Planning and Zoning Commission Meeting - Regular AGENDA

2. Bluebird Village Community Housing Project, P 21-027 Pre-Design Review

**STAFF REPORT
KETCHUM PLANNING AND ZONING COMMISSION
REGULAR MEETING OF MAY 11, 2021**

GRADING, DRAINAGE, AND UTILITY PLAN SHOWING BLUEBIRD VILLAGE (480 N EAST AVE)

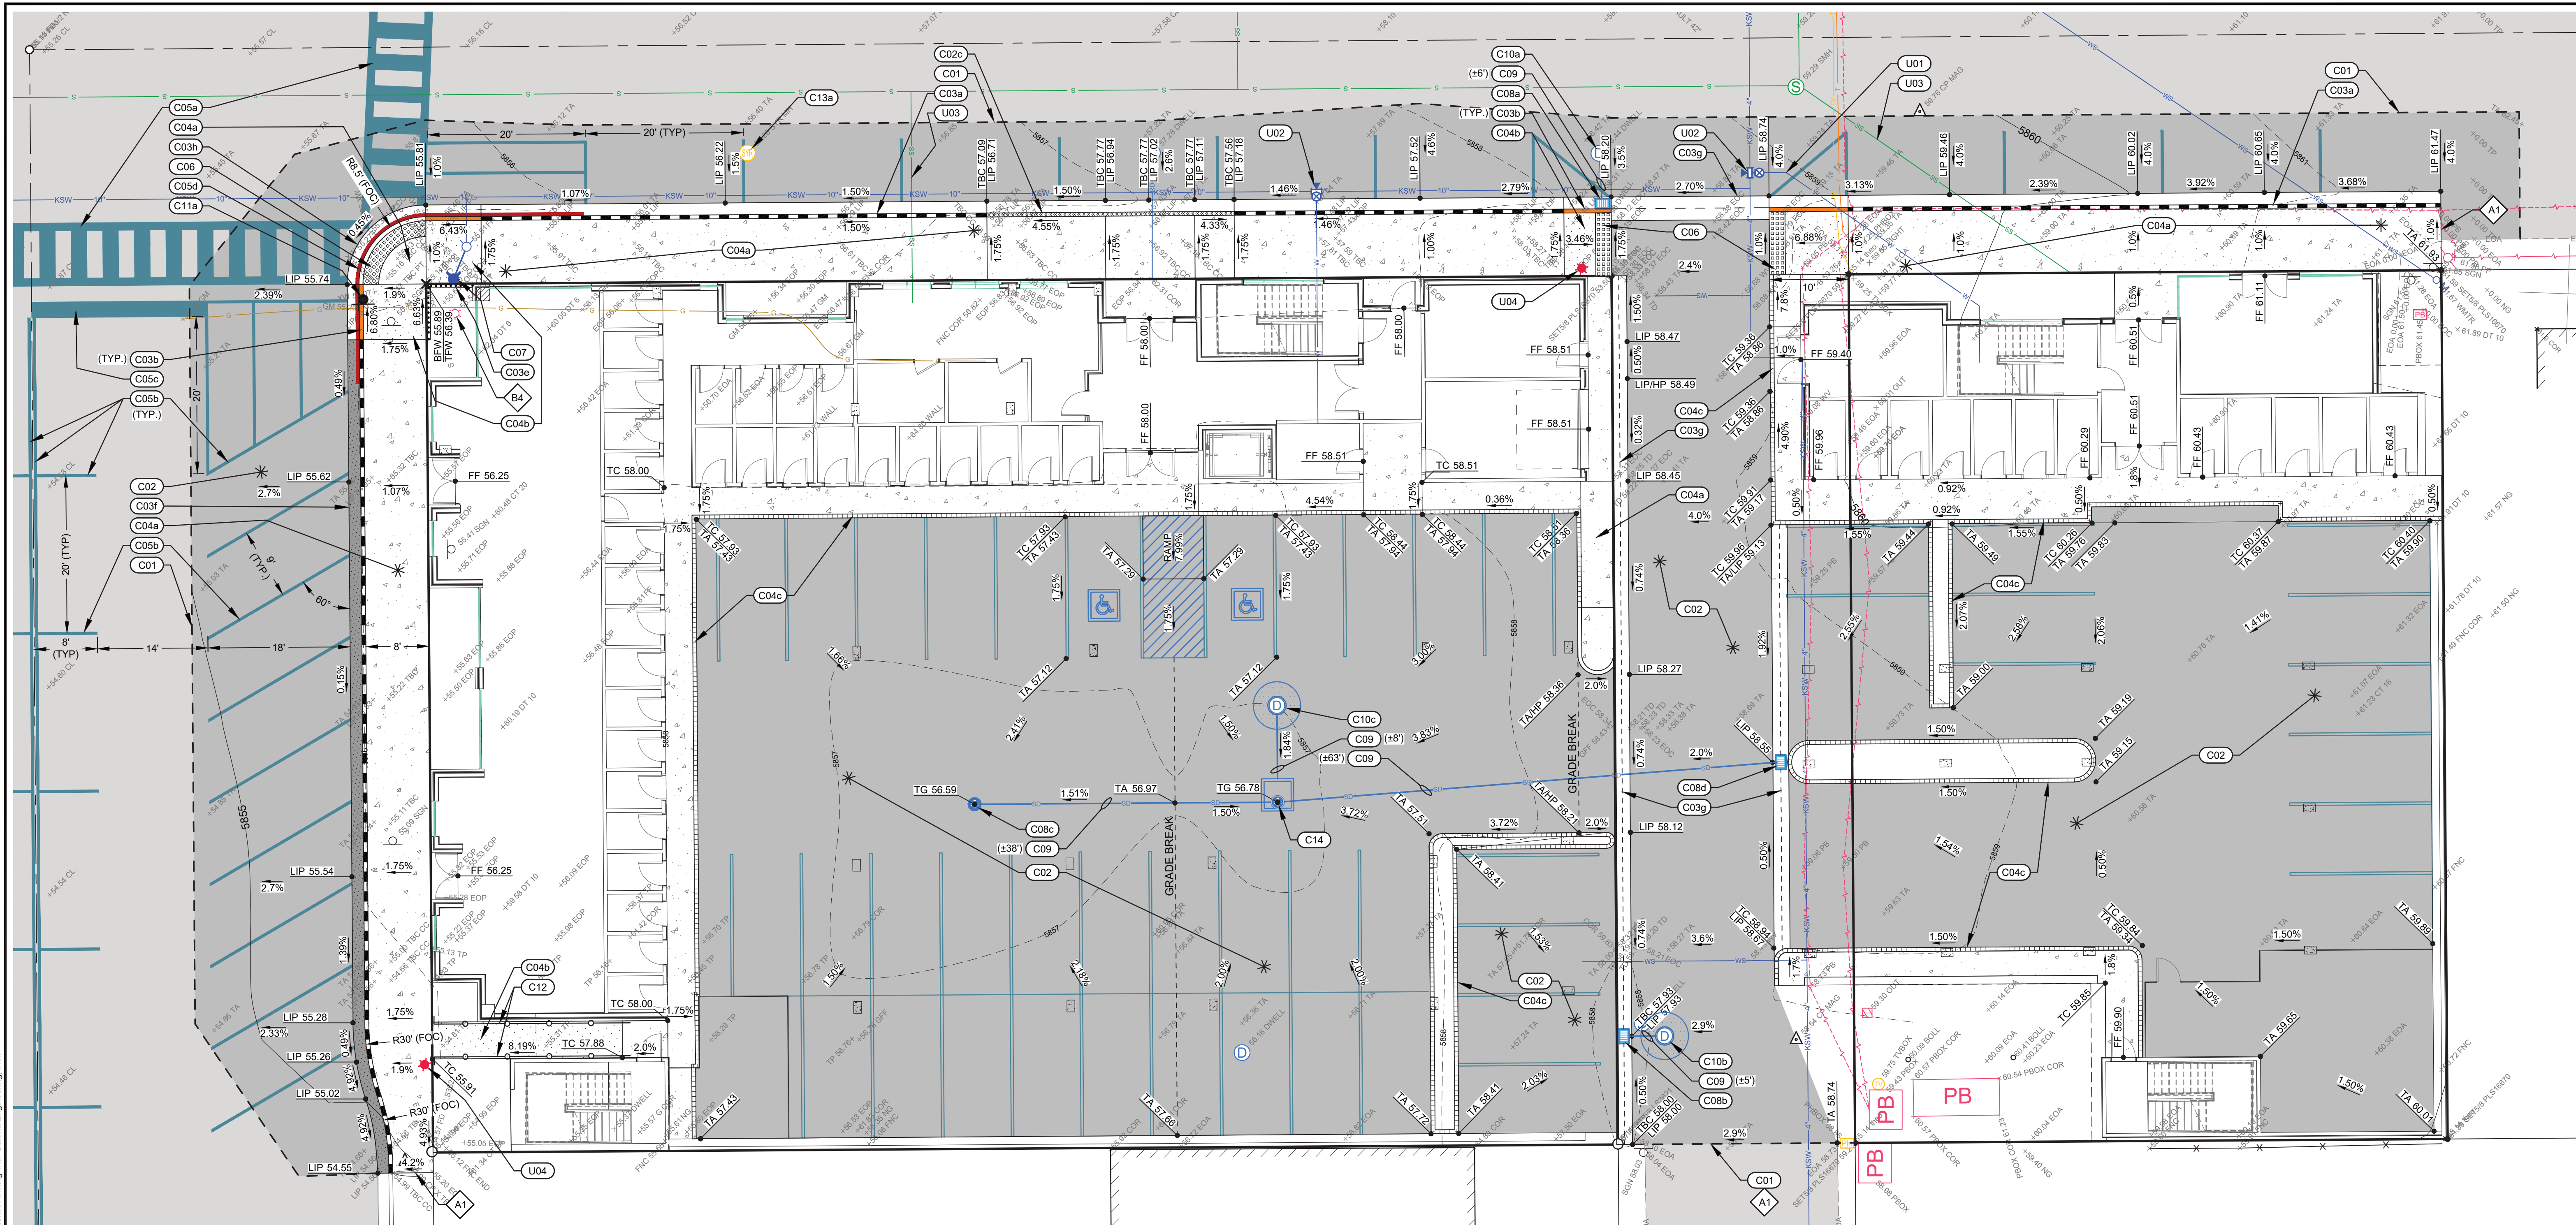
| Design Review Improvements and Standards (KMC §17.96.060) | | | | |
|---|--------------------------|--------------------------|---------------------------|---|
| | | | Staff Comments | <p>No changes to the lanes of travel or the street design are proposed with this project.</p> <p>The project’s circulation design is indicated on Sheet PDR C1.02 of the project plans.</p> <p>Prior to issuance of a building permit for the project, the City Engineer and Streets Department shall review the civil drawings to ensure adequate sight distances and proper signage for the project’s circulation design. The circulation design shall be indicated on civil drawings stamped by an Idaho-licensed engineer (KMC §12.04.020.C.3) included with the project plans submitted with the building permit application for final review and approval by the City Engineer and Streets Department prior to issuance of a building permit for the project.</p> |
| | | | Staff Comments | <p>The project qualifies as a substantial improvement project. The project’s sidewalk design is indicated on Sheet PDR C1.02 of the project plans. 8-foot wide sidewalks are provided along East Avenue and 5th Street. As part of the public improvements, a bulb out will be required at the SE corner of East Avenue and 5th Street.</p> <p>Final civil drawings for all associated ROW improvements shall be submitted with the Building Permit application to be verified,</p> |

| | | | Staff Comments | The applicant will improve the sidewalks to City ROW standards along both East Avenue and 5 th Street. Sheet PDR C1.02 indicates 8-foot wide concrete sidewalks, which is the required width for 100-foot-wide (East Avenue) and 60-foot-wide (5 th Street) rights-of-way. Final civil drawings for all associated ROW improvements shall be submitted with the Building Permit application to be verified, reviewed, and approved by the City Engineer and Streets Department. |
| | | | Staff Comments | The proposed sidewalk design connects with existing sidewalks. The project’s circulation design indicated on Sheet PDR C1.02 includes crosswalks to connect to the sidewalks along East Avenue and 5 th Street. The sidewalk along 5 th Street is designed to connect to future sidewalks to the east along 5 th Street. |

| | | | Staff Comments | <p>All storm water is proposed to be retained on site, including storm water from roof drains. Sheet PDR C1.02 indicates the proposed drainage improvements.</p> <p>Roof drain locations and specifications must be indicated the project plans submitted with the Building Permit application for review and approval by the City Engineer.</p> <p>Prior to issuance of a Building Permit for the project, the applicant shall submit a final drainage plan indicating grading, catch basins, piping, and drywells (KMC §17.96.040.C.2b & KMC §17.96.060.C.1-4) prepared by a civil engineer licensed in the state for review and approval by the City Engineer and Streets Department.</p> |

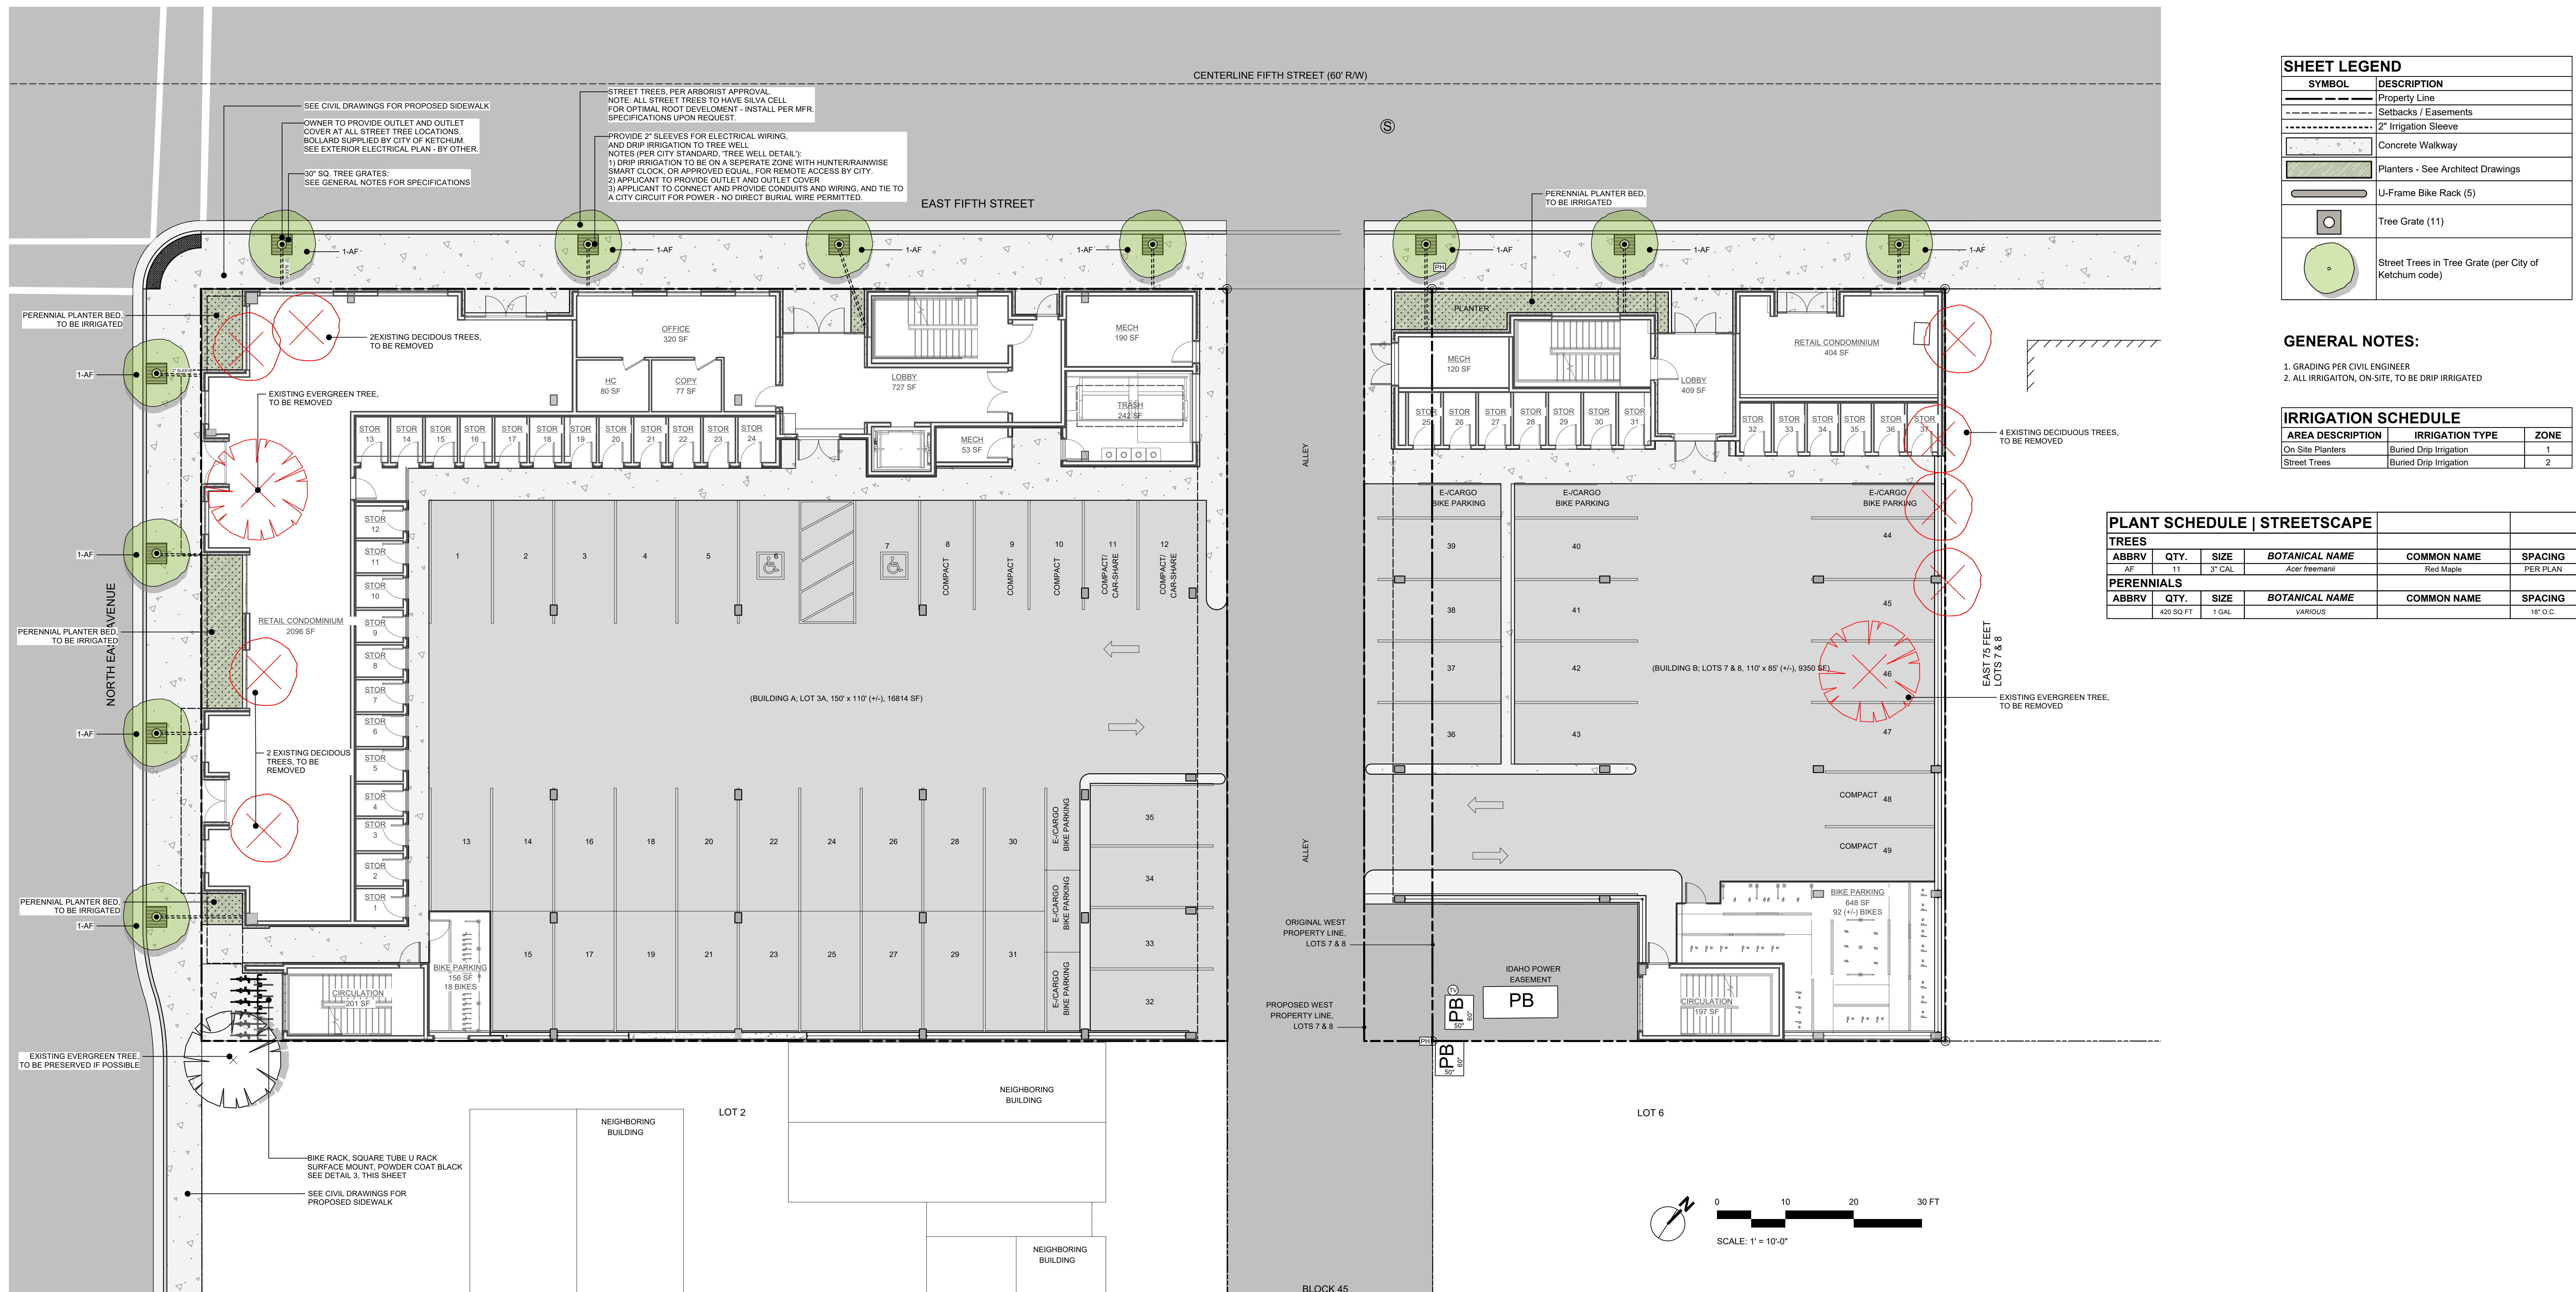
| | | | Staff Comments | Landscaping is indicated on Sheets PDR L1.01, L1.02, and L1.04. Landscape features soften the mass of building and provide visual relief to the vertical wall planes. Sheet PDR L1.01 shows 4 street trees along East Avenue and 7 street trees along 5 th Street. The trees soften the mass of the building and enhance the streetscape to create a walkable environment. At-grade planters along East Avenue and 5 th Street define the building entrances. Sheet PDR L1.02 shows landscaped roofs provided at the wall setbacks along 5 th Street, the south interior façade, and the east rear façade. Sheet PDR L1.04 shows the landscaped screening provided at the roof deck, which includes 6 trees and perennial beds. |

| IMPROVEMENTS AND STANDARDS: 17.96.070 - Community Core (CC) Projects | | | | |
|--|----|-----|--------------------------------|---|
| | | | Staff Comments | <p>Specifications for the proposed street trees are included on Sheet PDR L1.01 of the project plans. The notes indicate that trees will be a minimum caliper size of 3 inches and will be placed tree wells.</p> <p>Streetscape improvements must be indicated on civil plans with the Building Permit application for final review and approval by the City Engineer and Streets Department.</p> |

| | | | Staff Comments | Sheet PDR L1.01 indicates 10 total trees will be removed from the project site to accommodate the new Bluebird Village buildings. The replacement trees include 10 street trees and 6 trees that border the roof deck. |
| | | | Staff Comments | Specifications for the proposed street trees are included on Sheet PDR L1.01 of the project plans. The notes indicate that trees will be a minimum caliper size of 3 inches and will be placed tree wells. Streetscape improvements must be indicated on civil plans with the Building Permit application for final review and approval by the City Engineer and Streets Department. |
